## **Eketahuna Wastewater Treatment Plant**

### **Resource Consent Application No. 2005011178.01 – Discharge permits**

#### **Response to further information requested under section 92(1) of the RMA\**

**Response to Further Information Request APP-2005011178.01 - Eketahuna  
Wastewater Treatment Plan**

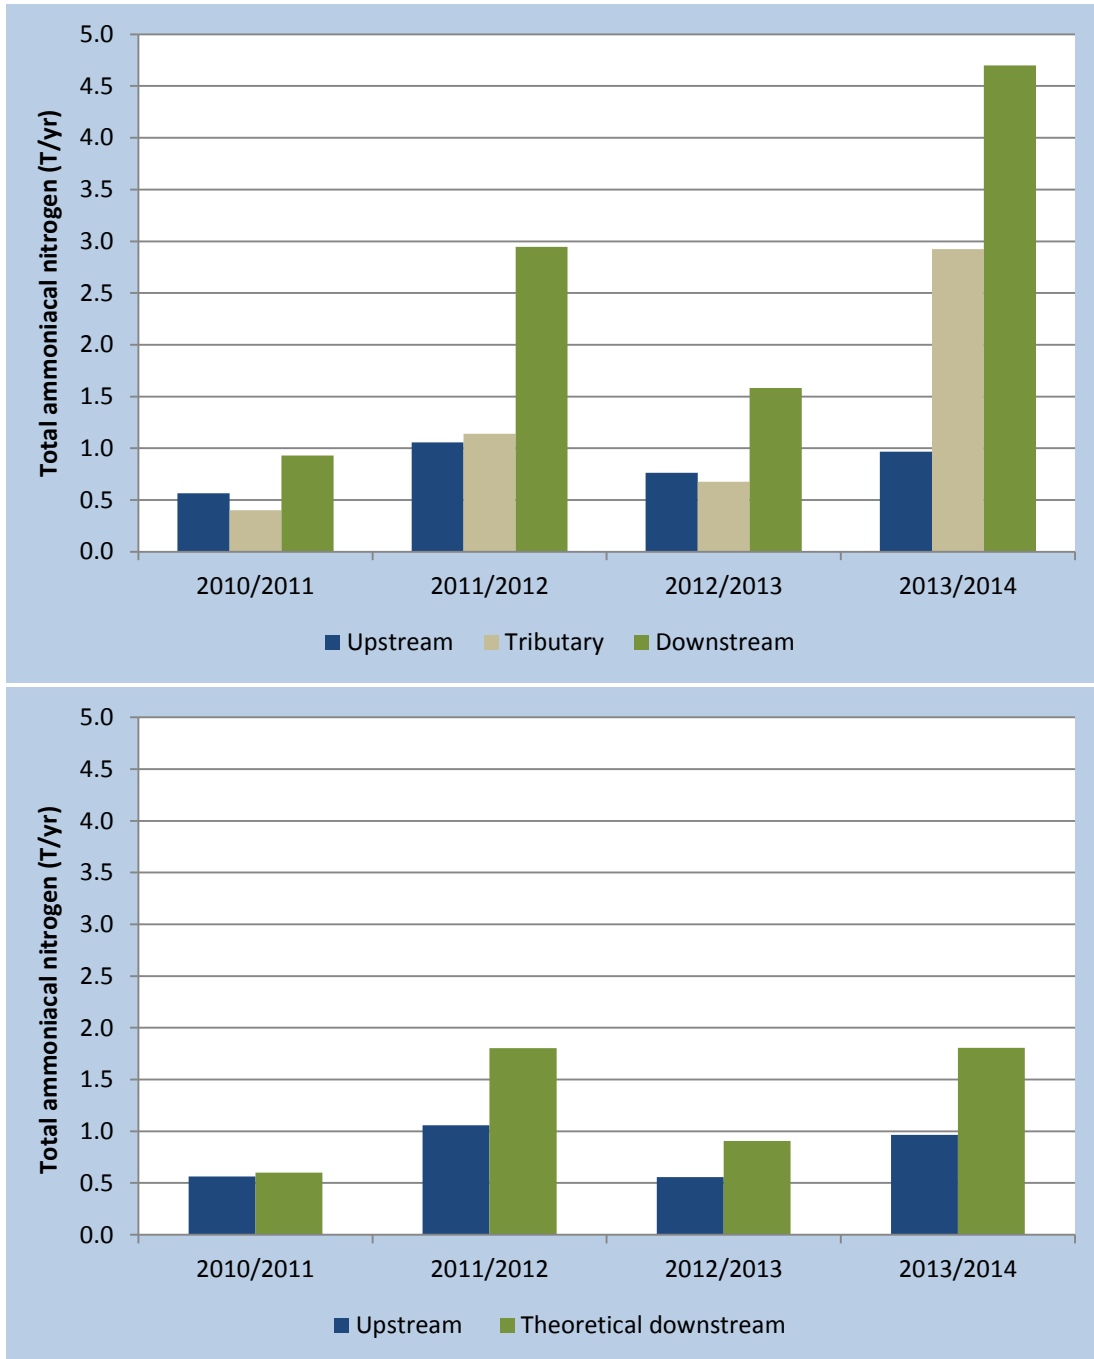
- 3 The water quality report shows there is a significant increase in the concentration of ammonia downstream of the discharge point (although well below the One Plan targets). Please provide comment as to whether this is the possible reason that we see more periphyton growth downstream of the discharge (preferential uptake and growth) compared to upstream and whether reductions in the ammonia component of the discharge will reduce effects on the Makakahi Stream. It is noted that currently the application seeks no reduction in the SIN component of the discharge.**

The relative role and possible preferential uptake of ammonia versus nitrate-nitrogen by periphyton are not well understood, and it is thus difficult to comment on this question at this stage. If preferential uptake of ammonia by periphyton was indeed established, it is possible that the smaller inputs of ammoniacal-nitrogen from the discharge could be causing a disproportionately high (i.e. for the same mass of nitrogen) effect on periphyton growth compared with the inputs of nitrate-nitrogen from the Ngatahaka Creek. It is noted that if that was the case, the ammoniacal nitrogen would be uptake very quickly by periphyton, and the effects would likely be very localised spatially.

As indicated above, the relative role and possible preferential uptake of ammonia versus nitrate-nitrogen by periphyton have not been the subject much scientific research, and are thus not well understood. An advice and research programme is however being started by Horizons, NIWA and Aquanet to investigate these aspects, with likely case studies in the Ruapehu and Manawatu Districts over the next two summers.

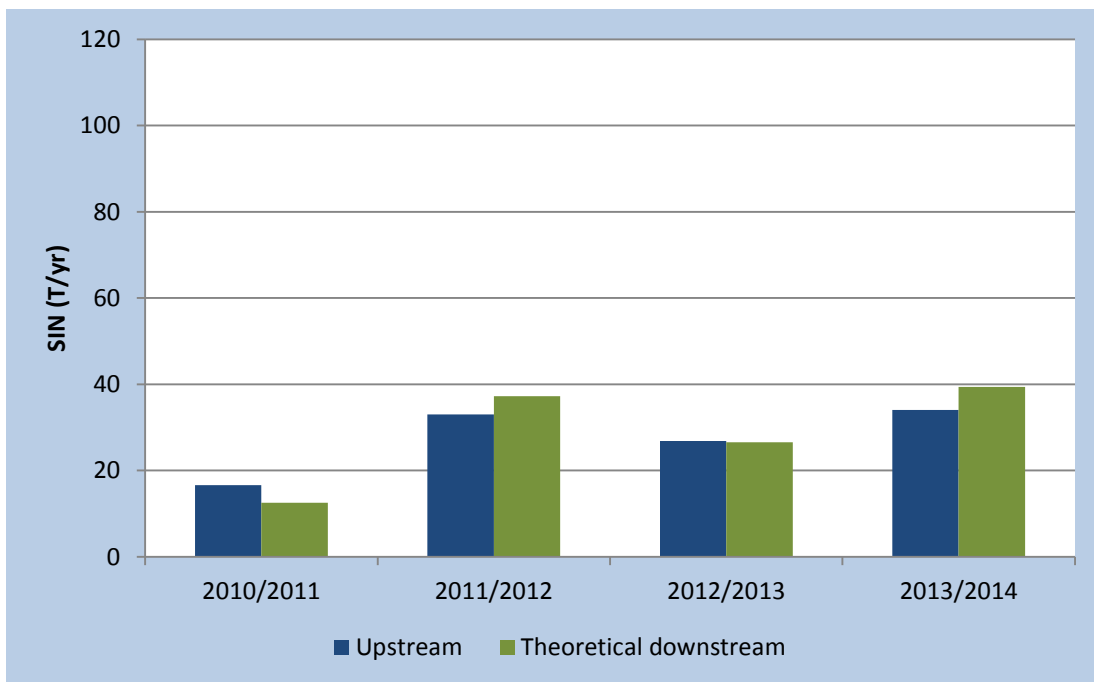
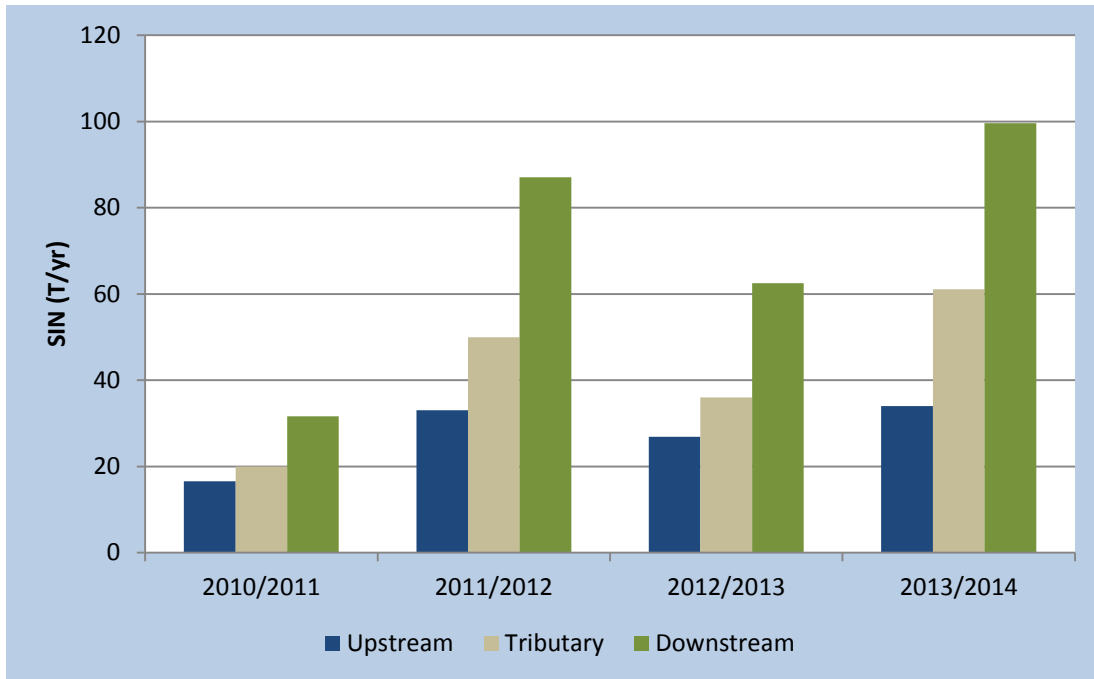
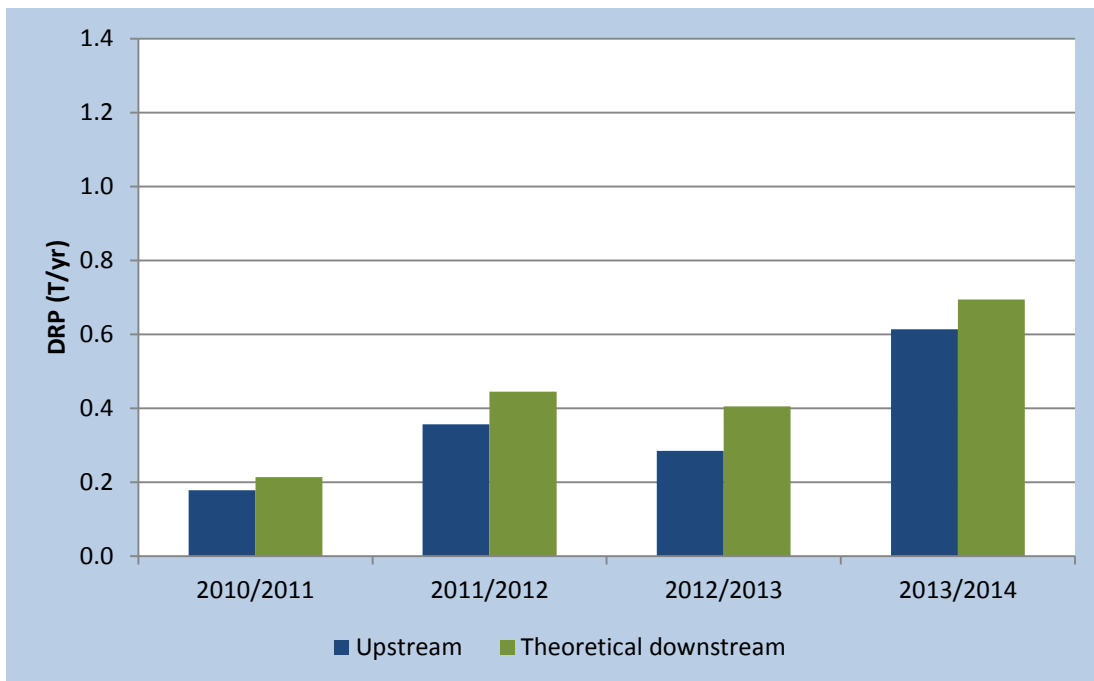
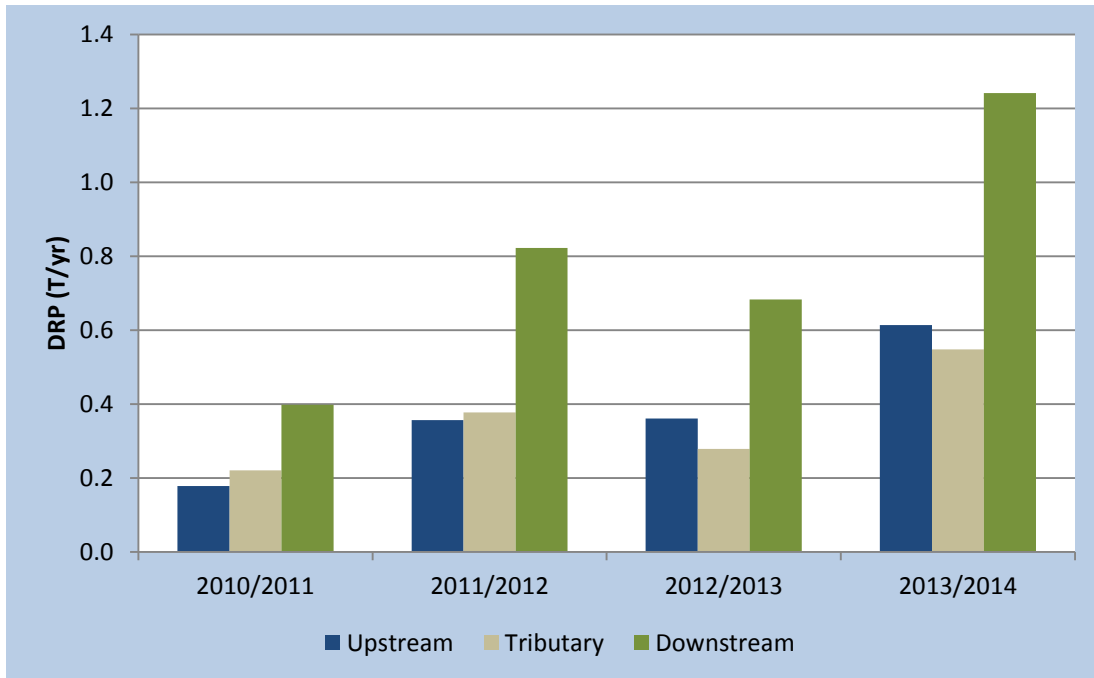
**4 pH and temperature averages - The application uses averages to represent pH and temperature. Generally, concern lies around the highs for temperature and the lows and highs for pH. Averaging this data removes these highs and lows and doesn't necessarily reflect the effects that are seen in stream. If available, please provide data showing the temperature high and the pH highs and lows**

Whilst it is correct that the graphs presented in the report (figures 14 and 15) show average pH and temperature calculating over different river flow ranges, the commentary in paragraph 3.1.8 correctly refers to comparing pH data to the pH ranges prescribed within the consent conditions and the One Plan targets, and temperature data to the maximum temperature set by the One Plan target. For more detail, Appendix A provides key descriptive statistics for all water quality parameters, including low and high percentiles (5<sup>th</sup>, 10<sup>th</sup>, 90<sup>th</sup> and 95<sup>th</sup> percentiles) and minimum/maximum values for all three monitoring sites and for a range of river flow conditions.
